**DEVELOPMENT CONSENT AUTHORITY
PALMERSTON DIVISION**

AGENDA ITEM: **3** **MEETING DATE:** 14 March 2025 **FILE:** PA2023/0255

APPLICATION PURPOSE: Variation to condition 4 of DP24/0043 for the purpose of an addition of a path and reduction in car parking width

SUBJECT SITE: Lot 11311 (5) Davies Court, Johnston, Town of Palmerston
Locality Plan at **Bookmark A**

Image 2 – proposed changes to site layout

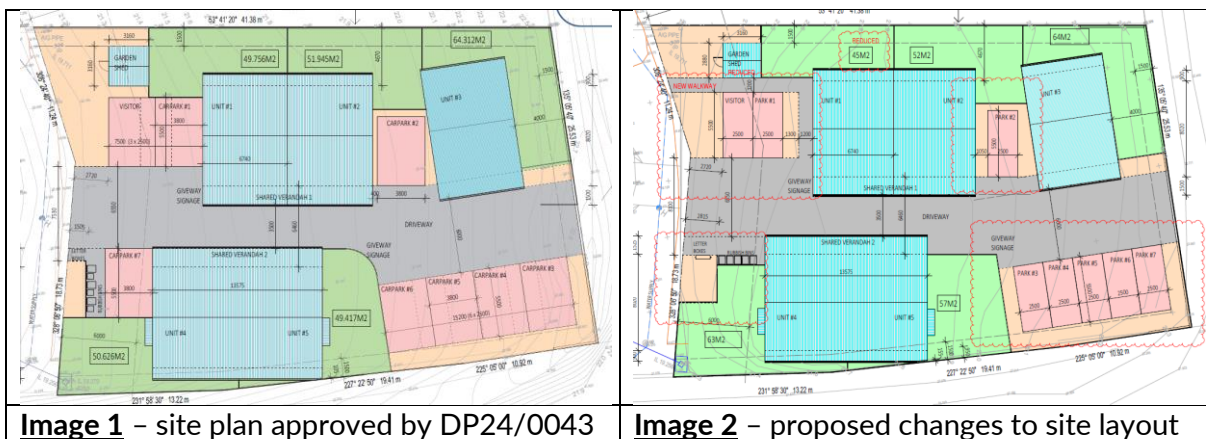
The application seeks consent to vary the drawings that were endorsed as forming part of Condition 1 of DP24/0043 to allow the following changes:

- car parking layout (repositioning of car parking spaces, amended design of car parking spaces)
- minor changes to building setbacks
- amendments to boundaries and areas (m²) of private open space
- amendments to landscaping (location of planting)
- dedicated pedestrian access to site from street boundary.
- dimensions / locations of door and windows (south and north elevations)
- reduced size of outbuilding (shed)

5.2.4.4 (Layout of Car Parking Areas)	<u>Dimensions of car parking spaces</u> <ul style="list-style-type: none"> • DP24/0043 showed / approved car parking spaces 3.8m wide (greater than the 2.5m NTPS2020 minimum) • Updated drawings reduce all bay widths to 2.5m <u>Car Parking Layout</u> <ul style="list-style-type: none"> • Car parking space #7 has been relocated to north side of driveway (due to amendments of private open space) 	<ul style="list-style-type: none"> • length and width of bays complies with NTPS2020 • layout is considered to be functional • reduced car parking bay widths are not considered to be "conveniently measurable" as widths still comply with NTPS2020.

The reduction in width of the car parking spaces does not change compliance with the NTPS2020 requirements. However, DP24/0043 granted a variation to Clause 5.2.4.1 (Car Parking Spaces) for the following reasons:

It is considered that the proposed changes to car parking width may have an impact on the future amenity of the area, should the further parking be required. However, the DCA also reasoned that *the reduced number of car parking is appropriate for the unique design of the development which provides for single-bedroom dwellings and, as identified by the applicant at the DCA meeting, self-limits the number of occupants to below what would normally be anticipated of a*

That, pursuant to section 57(3) of the *Planning Act 1999*, the Development Consent Authority consent to the application to vary condition 4 of Development Permit DP24/0043 for the purpose changes to car parking layout, widths of car parking spaces, building setbacks, private open space boundaries, design of shed and doors and windows of dwellings.
